HISTORIC LANDMARK COMMISSION
JUNE 24, 2019
APPLICATION FOR A CERTIFICATE OF APPROPRIATENESS
LHD-2018-0031
1404-10 W. 9TH STREET
SMOOT/TERRACE PARK HISTORIC DISTRICT

PROPOSAL

Rehabilitate and add to two contributing buildings. New construction on the property was approved at the May 20, 2019 meeting.

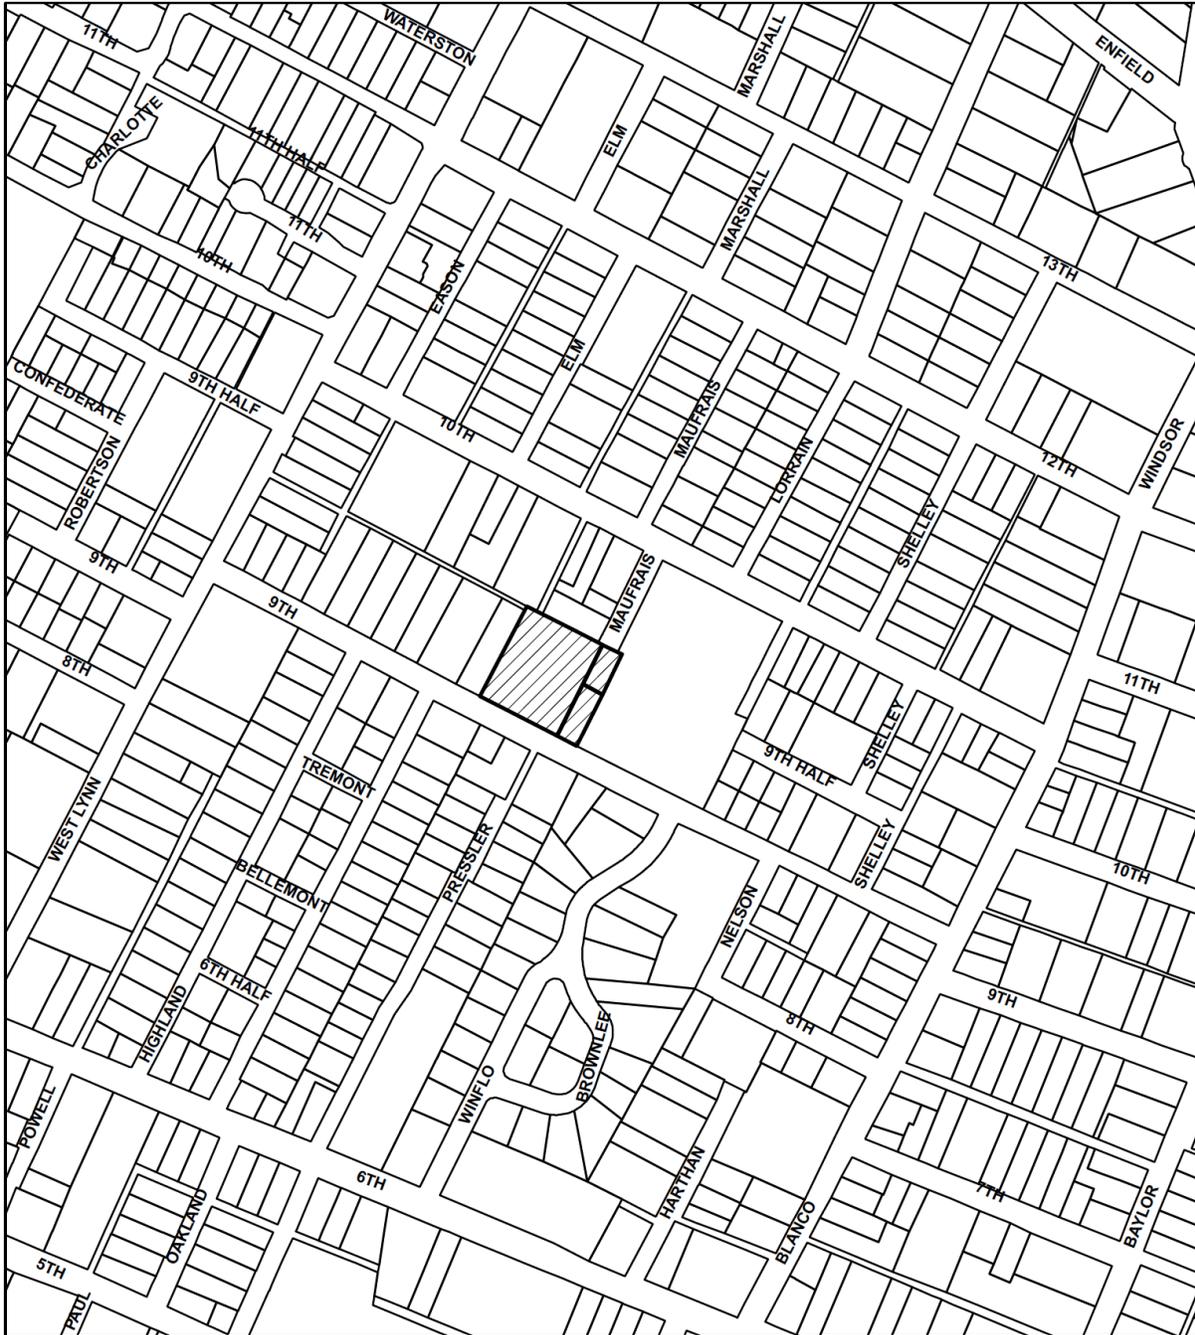
- Evaluate condition of windows and siding, and replace historic-age material only where necessary;
- If windows must be replaced on the front walls, relocate windows from the sides and rear where size permits;
- Remove the proposed door hoods from the front of 1408 W. 9th Street;
- Add entry stairs to the front of 1410 W. 9th Street;
- Retain the entrance on the east wall of 1410 W. 9th Street;
- Change the proposed door on the south wall of 1410 W. 9th Street to a pattern more in keeping with the band of windows; and
- Select posts and railings for the front porch of 1410 W. 9th Street that are similar to posts and railings of compatible contributing buildings in the district.

The committee was supportive of adding a second entrance to the front of 1408 W. 9th Street, recognizing that is an unusual situation.
